# SERVICE BULLETIN

## FITMENT OF OUTER RUDDER PEDAL GUARD PLATE (MODIFICATION N642)

**NMD-27-34**  
Page 6 of 6

Figure 1 Installation of Mod N642

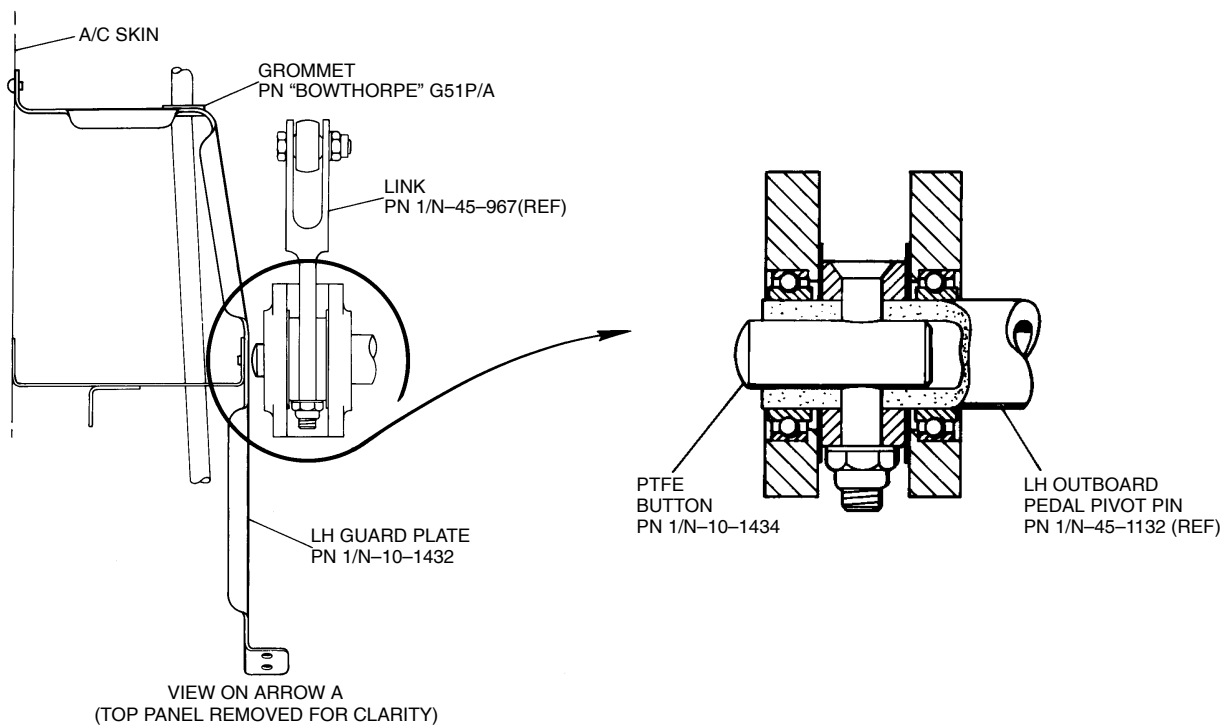
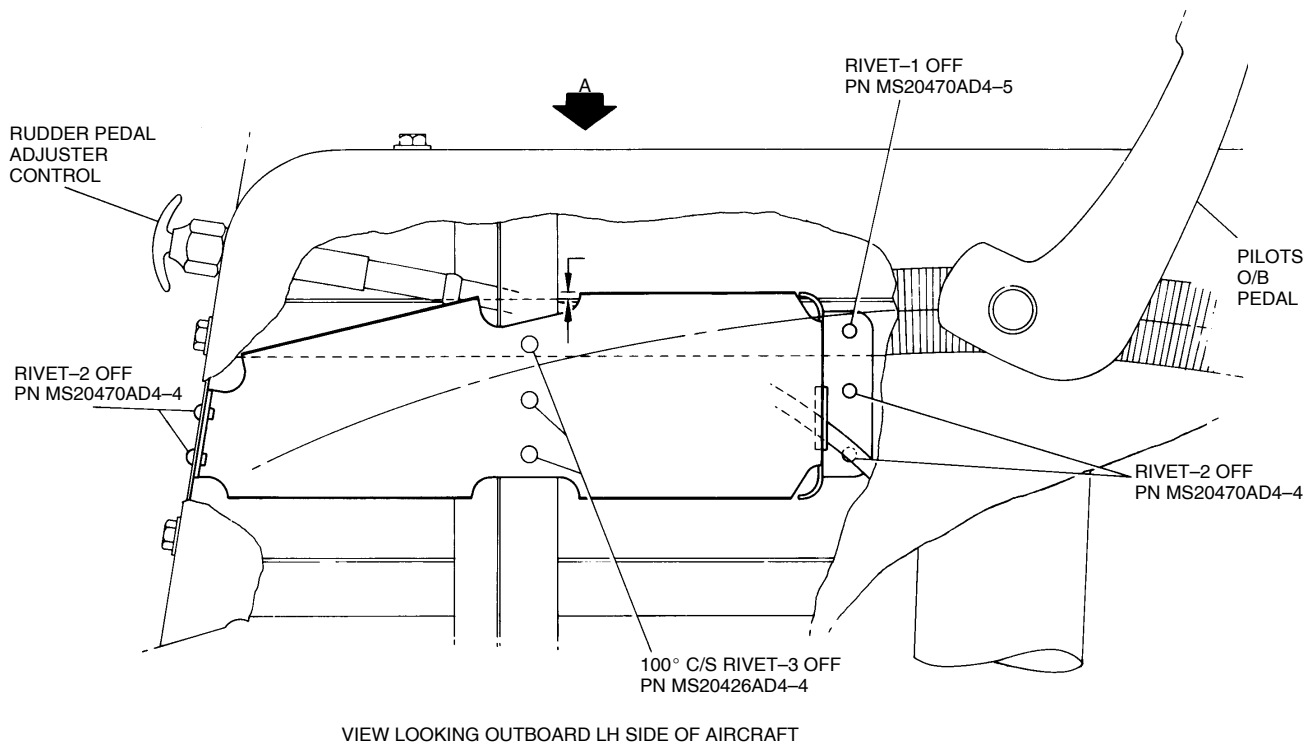
A number of instances have been reported of the outboard rudder pedals fouling the adjacent structure at Sta 93.1. The degree of obstruction to rudder pedal movement only occurs when the pedals are adjusted to the fully aft or near aft position combined with the magnitude of side force applied to the pedals.

A guard plate is riveted to the LH and RH structures between Sta 88.0 and 97.0 approximately and between waterlines 66.50 and 69.25 to cover the structural areas where rudder pedal fouling may occur. A PTFE 'button' is fitted in the outer end of each outboard rudder pedal pivot pin to minimise any friction resulting from contact between the pedal assembly and the guard plate.

- H. Place the LH guard in position (Ref Figure 1) and using a No. 30 (3.3 mm) dia drill, drill the three rivet holes (middle of guard plate) through the plate and structure. Fit grip pins in top and bottom holes to retain plate in position then drill remaining five rivet holes through plate and structure using same size drill.

- I. Remove the LH guard plate and countersink the three holes in the middle of the plate with a 100° countersink to suit rivets PN MS 20426AD4-4.
- J. Touch up all bare metal with suitable primer; when dry, wet assemble the guard plate to the structure using pigmented chromate jointing compound and rivet up with rivets as detailed in Figure 1. Remove excess jointing compound.

Ensure that countersunk head rivets are flush with guard plate surface, otherwise rivet heads may accelerate wear on PTFE button.
